December 13, 2001

Work Plan Addendum for Monitoring Well Installation and Soil Boring

Former Chevron Station #9-2960 2416 Grove Way, Castro Valley, CA

DG92960G.3C01

Site Plan

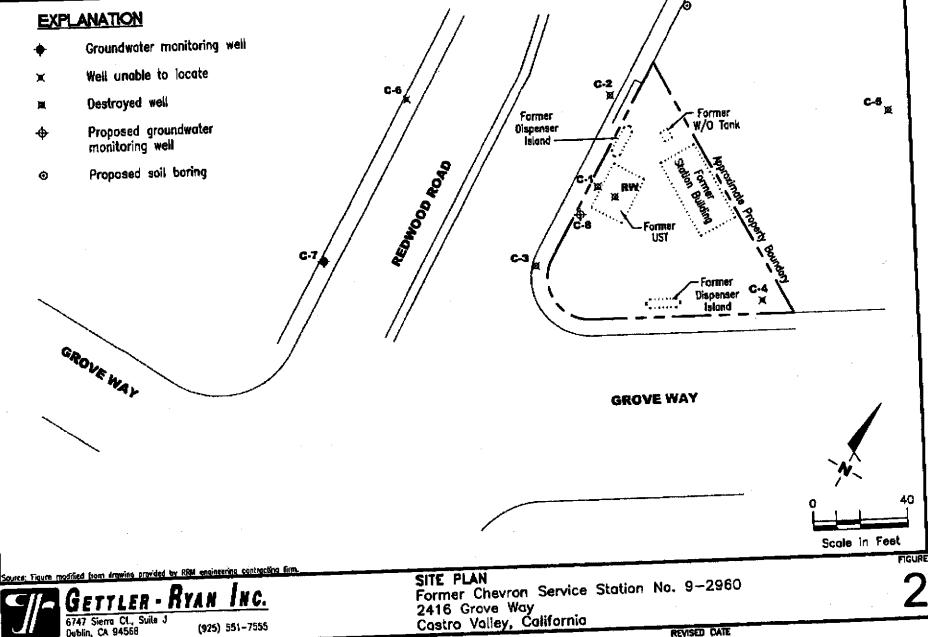
- In an effort to evaluate the dissolved hydrocarbon plume directly downgradient of the former UST complex and in the area of former groundwater monitoring wells C-1 and C-2, GR proposes moving proposed well C-8 southwest of the former UST area.
- GR proposes to advance one soil boring to groundwater and collect a grab groundwater sample at
  a location north of the property boundary as presented in Figure 2.
- Soil and grab groundwater samples will be analyzed as described in the original work plan, but will be submitted to Lancaster Laboratories (ELAP #2116) for analysis.
